Re: Community Feedback for LOC2021-0043 at CPC

The Rutland Park Community Association conducted an online survey of our communities regarding the sale and / or repurposing of the 5 acre section on the west side of Richmond Green Park. Ninety (90) percent of respondents are fully opposed.

Figure 2 – City of Calgary Water Department Site Map

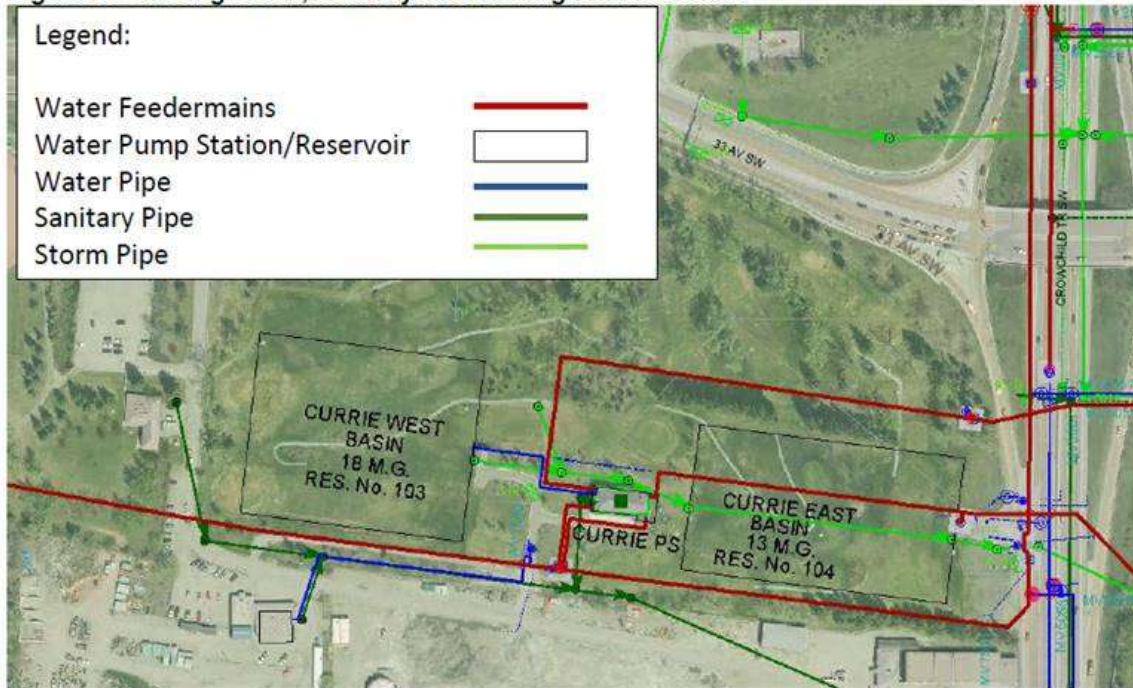
Not only is the Currie facility one of the oldest in the city but it is one of the largest. Similar facilities exist on the south end of Nose Hill (water storage basins 118 and 119) and in Panorama Hills (storage basin 120). Despite being directly adjacent to park space both the Nose Hill facility and the Panorama facility are fully enclosed and fenced.

FIGURE 1-1
Concept of Delay Calculation (adapted from Garcia, 2001)

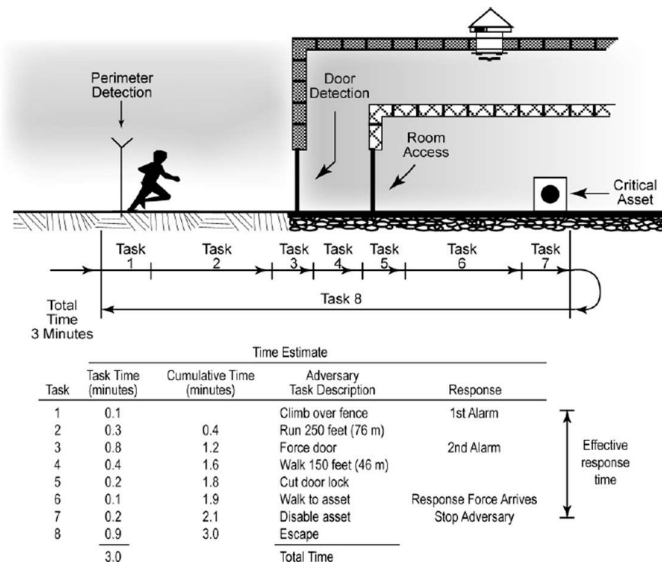
An example page of one of these tables is included as Figure 3. **This standard talks about the need to complete a vulnerability assessment for determination of threat countermeasures.** This includes for example determining the time it would take for a perpetrator to contaminate water or damage equipment. Figure 4A is an example tool used for such a vulnerability assessment. A senior City of Calgary Water Department employee, when queried, admitted that to his knowledge no threat assessment had been conducted for the Currie water storage facility.

Figure 5 – Current Proposed Single Substandard Ball Diamond

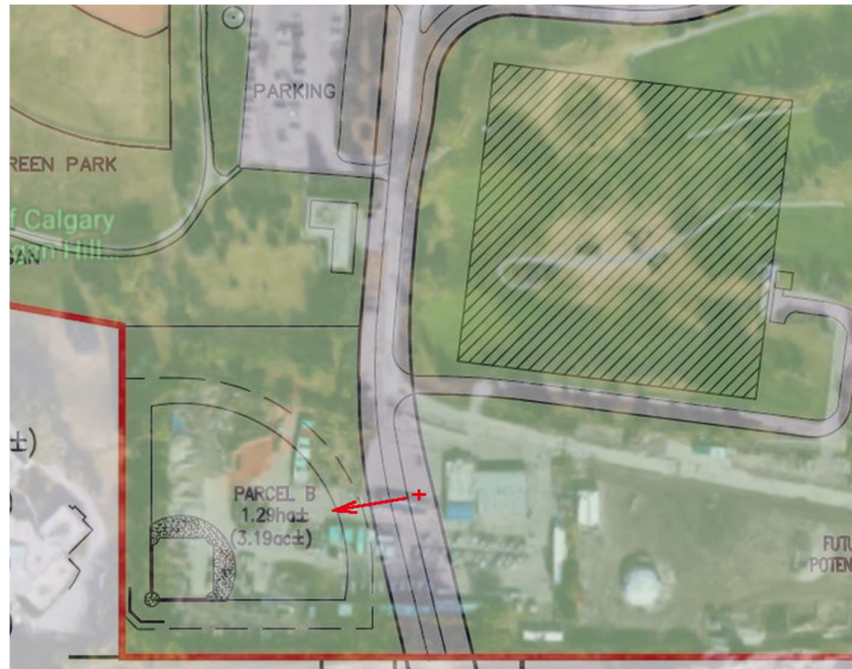
The latest proposal from RE&DS only includes for provision of a single, substandard, ball diamond located on the South West corner of the OWC site. A hit to right field will land balls on a newly construct BRT route. In addition and somewhat unbelievably the site is located on the side of a substantial hill.

The red cross and arrow in Figure 5 shows the site and direction of a picture taken of this site that is provide as Figure 6. There is an approximately 20 feet change in elevation from the space behind where the back stop would be to the edge of where the outfield would be. **Construction of this proposed ball diamond will require a retaining wall that would cost on the order of \$500k. Is the city serious about building a substandard ball diamond beside a BRT road for which an extremely expensive retaining wall would be required?** Figure 7 shows a retaining wall of the expected scale that would be required. Has city engineering contacted the Westcare facility operators regarding this as tie backs may have to be driven underneath their facility?

Figure 8 – Prior proposed Quesnay Wood Drive

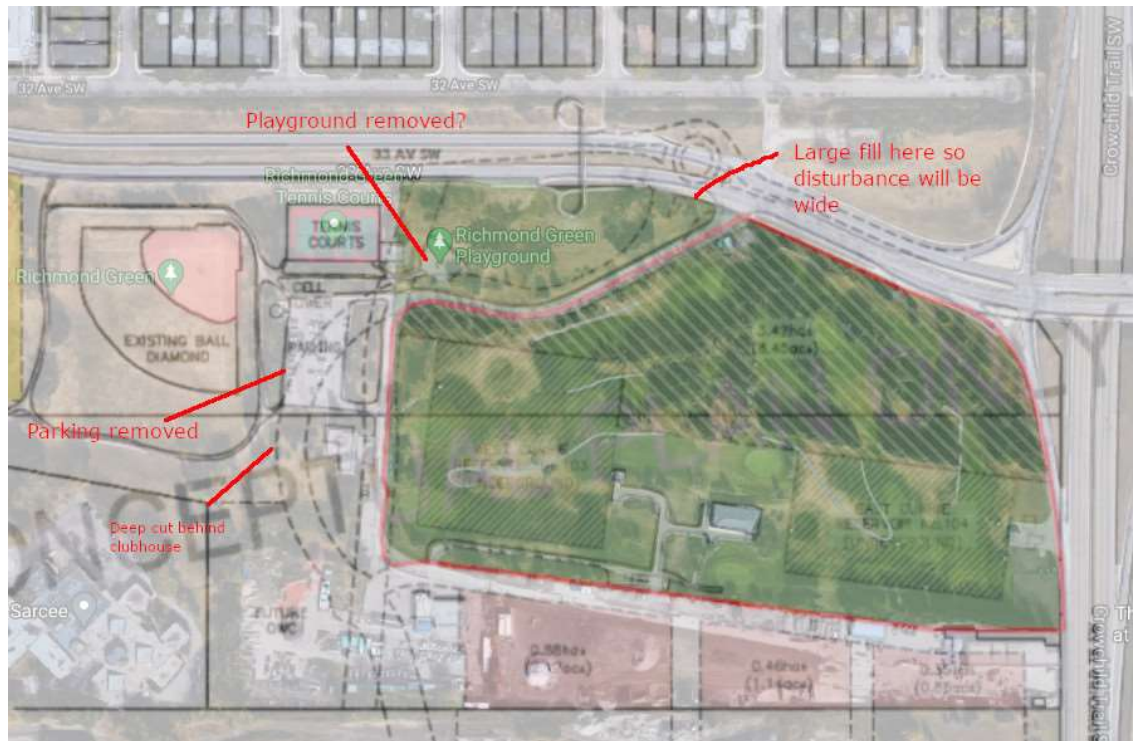
Until last week the already approved but not yet built secondary access road to Currie Barracks (Quesnay Wood Drive) has been shown passing through the existing Richmond Green parking lot and tot park. This is shown in the proposal image provided in Figure 8.

Figure 9 – Current Quesnay Wood Drive proposal

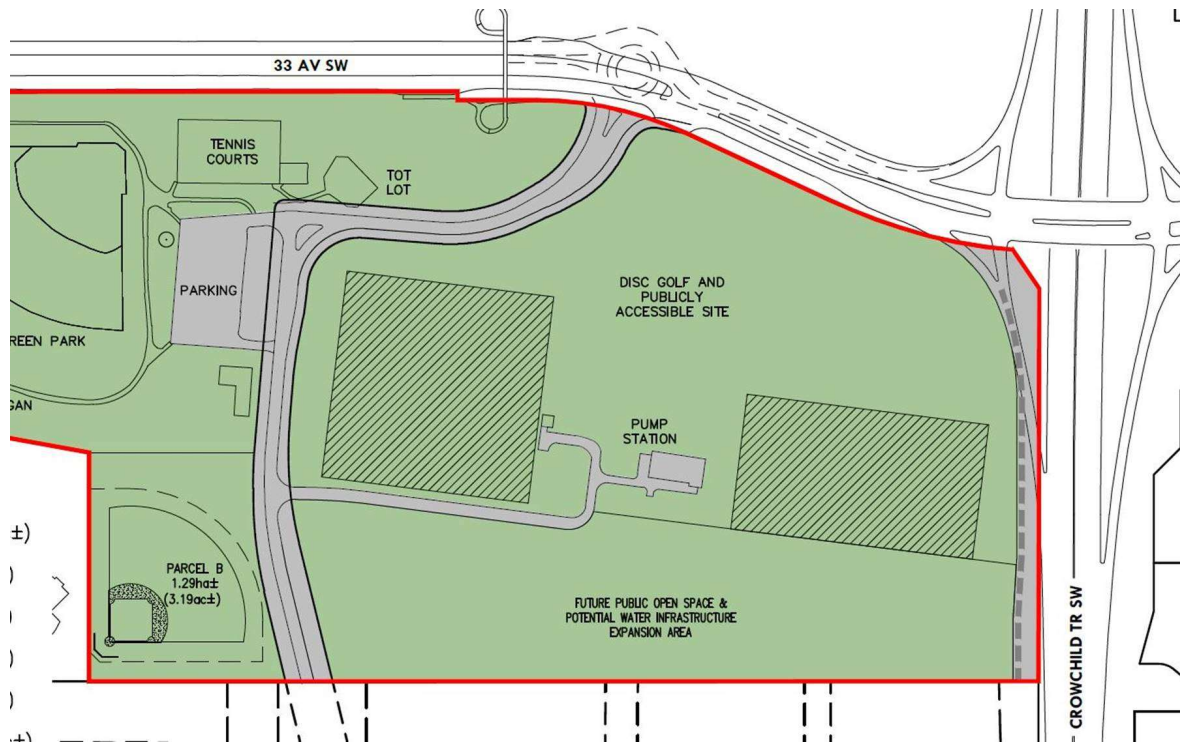
Seemingly based on identification of the essential nature of the parking facilities for the existing ball diamond, tennis courts and sliding hill the current proposal now shows the road following the path of the existing OWC site access road. This is shown in Figure 9.

The proposed change is appreciated only from the perspective of as an attempt to preserve existing facilities but **based on the seriousness of the existing ball diamond proposal and use case proposal of the Currie water storage facility there is significant concern that this road proposal is also not considered.** The CFB West Policy Area will be the home to over 21,000 people once it is built out. Will the proposed traffic circle and right turn heading south facilitate the thousands of vehicles attempting to enter Currie via this route at rush hour? Will this cause traffic to back up onto Crowchild Trail?
